Modification of OBD MAINLINE

Figure 3

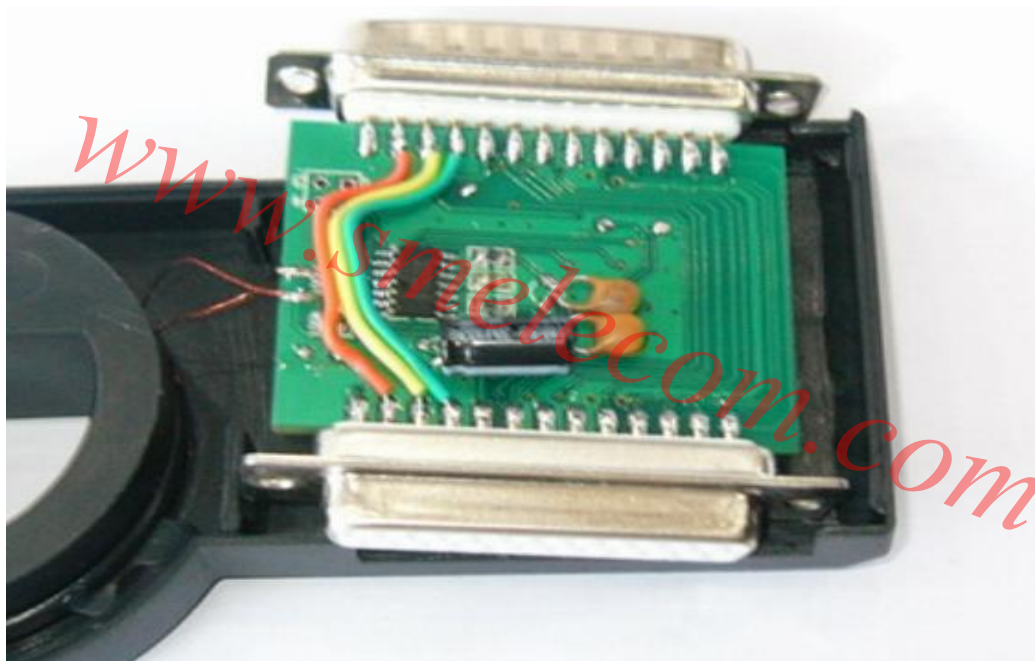
Please disassemble the transponder adapter if you bought it before December 19th,2011, connect wires as Figure 3

After finished ,please assemble it well.
